## SERVICE BULLETIN

POWER PLANT - BRACKETS AND RACEWAYS, HARNESS SUPPORT, FAN - INTRODUCTION OF MODIFIED  
SUPPORT BRACKET AND SPACER FOR HARNESS RACEWAY ADJACENT TO EEC - CATEGORY CODE 6 -  
MOD.ENG-71-0116

V2500-ENG-71-0116

Enlarged view at AB - Position of support brackets of harness raceway - Before and after alteration  
Fig.2

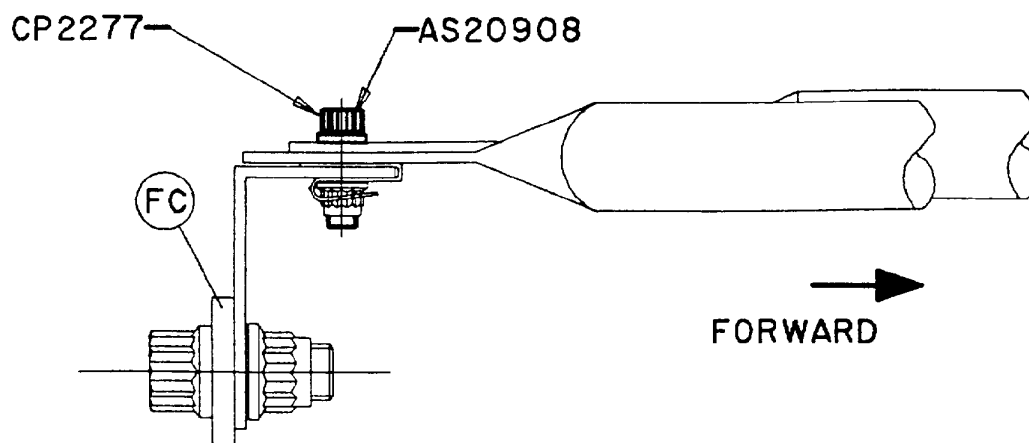
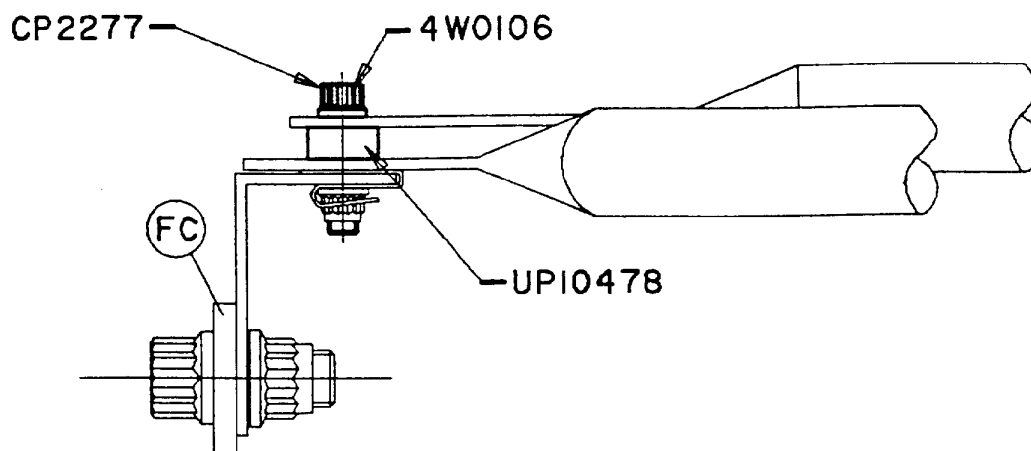
- (1) A 0.200 in. (5 mm) aluminium spacer and longer bolt at clip point 2277.
- (2) A raceway support bracket with a decrease in height at flange FB and with the clipping hole for clip point 2432 in a different position.
